THE DESIGN OF THE UNECE HGV DVS FOR TECH NEUTRAL CAB DESIGN

EQUIVALENCE BETWEEN THE EXISTING METHOD AND PROPOSED AMENDMENT

DR STEVE SUMMERSKILL, PROF. RUSSELL MARSHALL, DR ABBY PATERSON, ANTHONY ELAND

Original method in the standard - Front

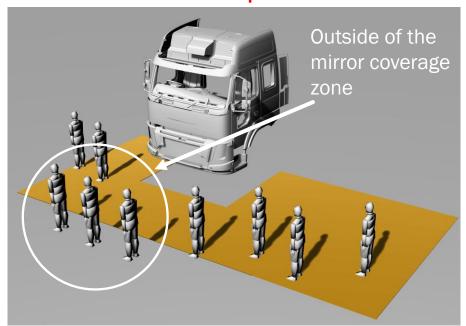
The vehicle fails the minimum requirement to the front and must be improved – e.g. lowered overall – lower windscreen and dashboard

Amendment version - Option 3 method - Front

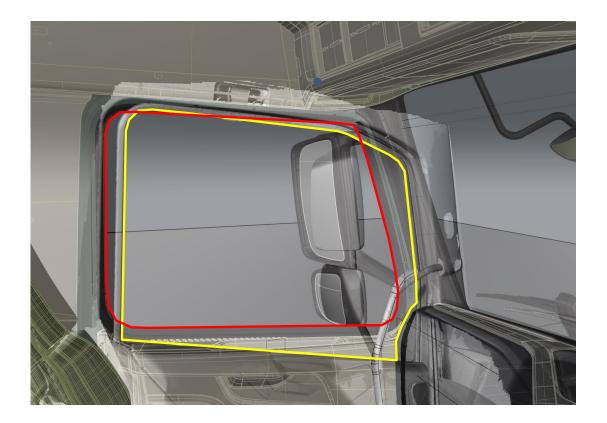
This vehicle fails the minimum requirement to the front and must be improved – manufacturers can gain volume by removing mirrors, lowering window edges and can then pass

NO improvement to frontal direct vision blind spots

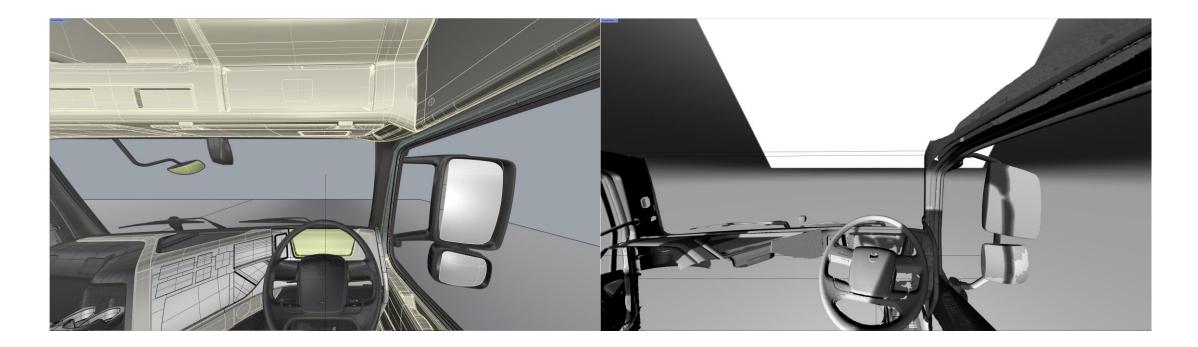
- The TfL DVS method produced a score for the Volvo FM which meant that it not could achieve a three star rating.
- In 2024 3 star becomes the minimum requirement
- The TfL DVS does not take the separated approach (this was developed for the UNECE version)
- Volvo therefore redesigned their truck to improve direct vision to the sides only to improve the design

- If we overlay the new and old designs we can see that the new design (yellow path) has a lower edge for the passenger window allowing more volume to be seen to the side
- The red path shows the old design

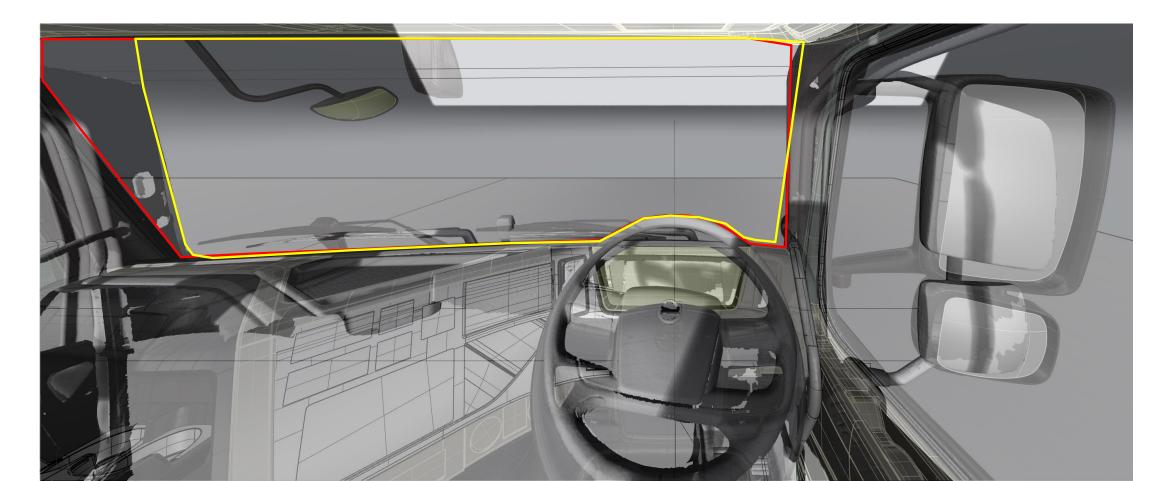
- The TfL DVS method produced a score for the Volvo FM which meant that it not could achieve a three star rating.
- In 2024 3 star becomes the minimum requirement
- The TfL DVS does not take the separated approach (this was developed for the UNECE version)
- Volvo therefore redesigned their truck to improve direct vision to the sides only to improve the design

- If we overlay the new and old designs we can see that the new design (yellow path) has the same dashboard height Therefore front VRU distance will be the same, no improvement to front direct vision
- Other improvements were narrower A-Pillars, reduced obscuration by the mirror housings
